Warner Ranch PUD 42 - Amendment No. 3
ZONING ZON1712-002

REQUEST: Approval of request to allow single-family attached residential development.

Warner Ranch PUD 42 Amendment No. 3
ZONING ZON1712-002

Exhibit D: Development Standards

Exhibit C-1
Warner Ranch PUD Plan
 Street arrangement is diagrammatic only.

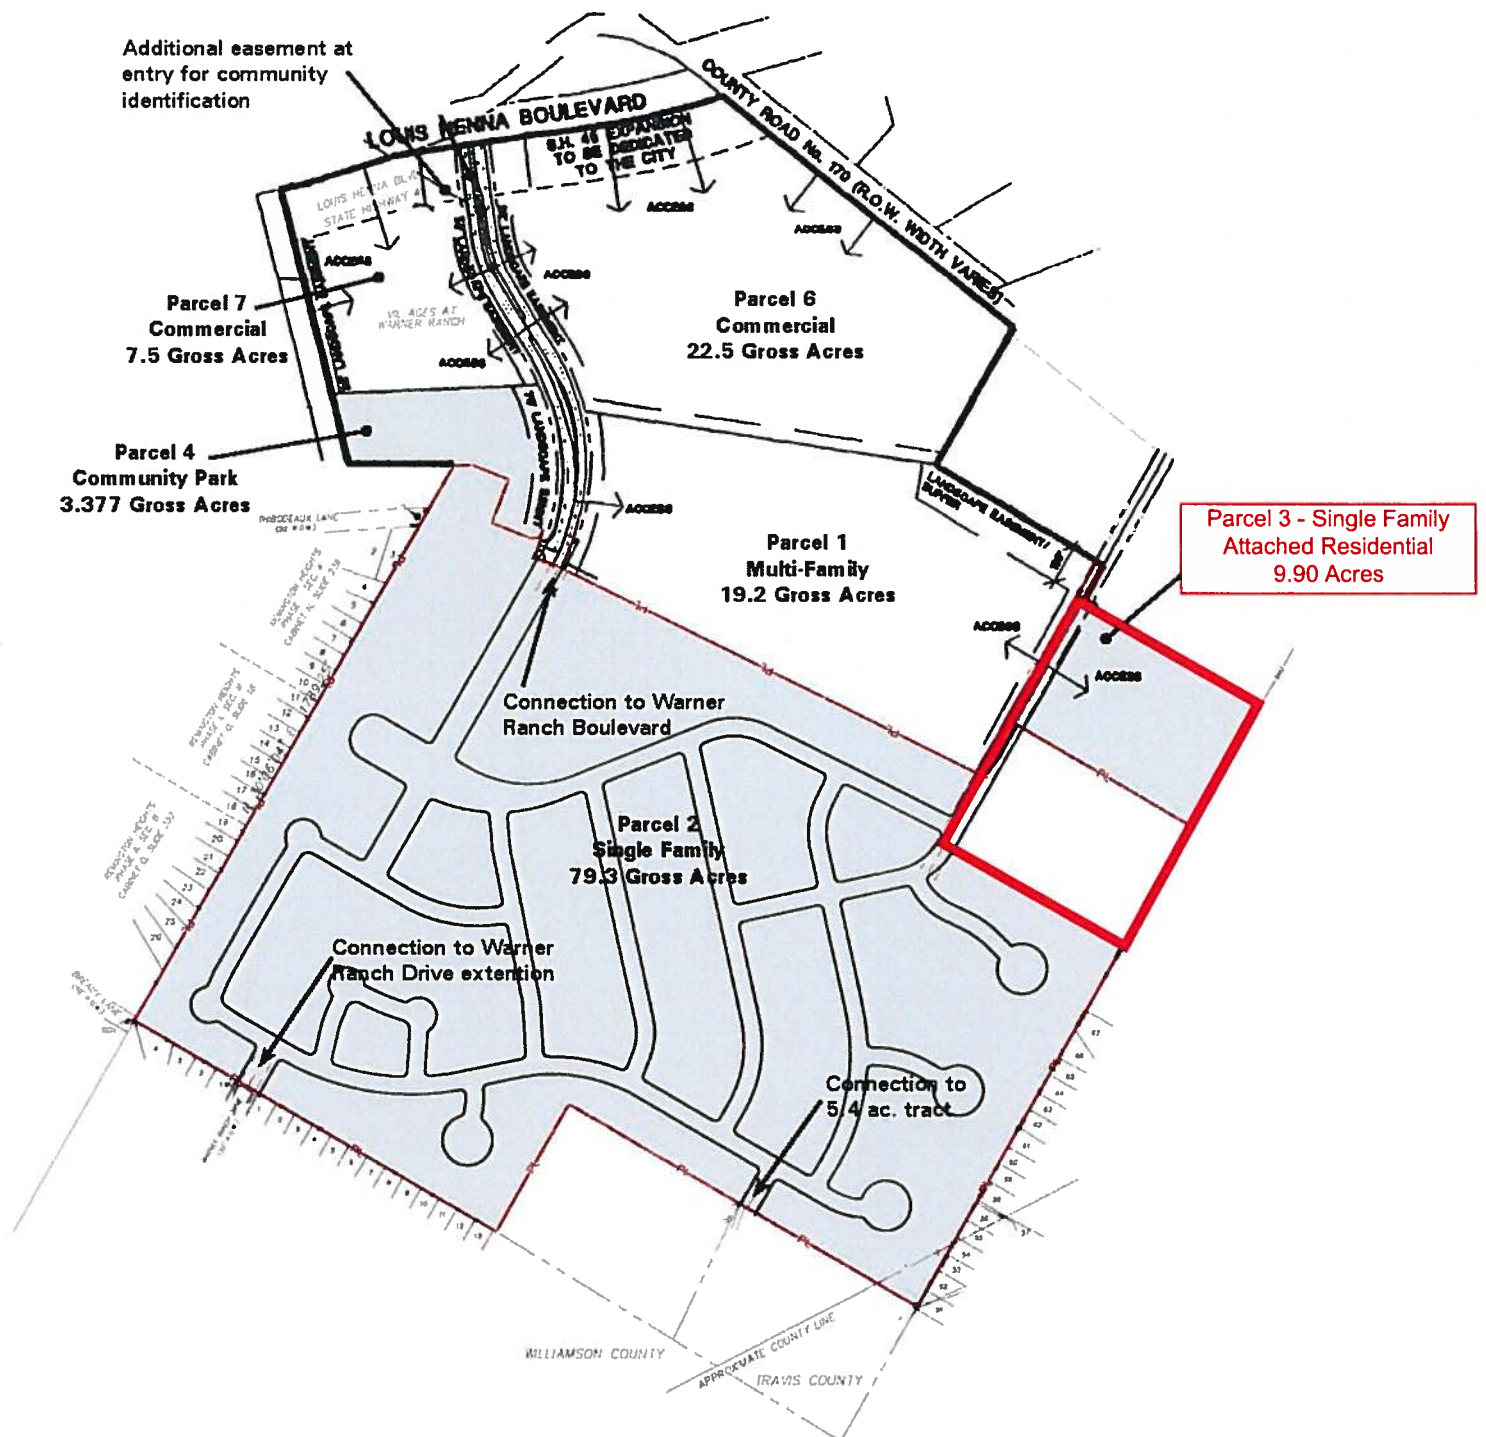
The amendment will add approximately 5 acres to Parcel 3 of the PUD, increasing the size of the parcel to a total of almost 10 acres. In addition, the land use allowed on Parcel 3 will be changed to provide for single family attached units, following the TF (Two-family) zoning district standards, with some exceptions. Parcel 3 of the PUD currently allows for either townhouses or single-family standard lots and these uses will no longer be allowed with the amendment.
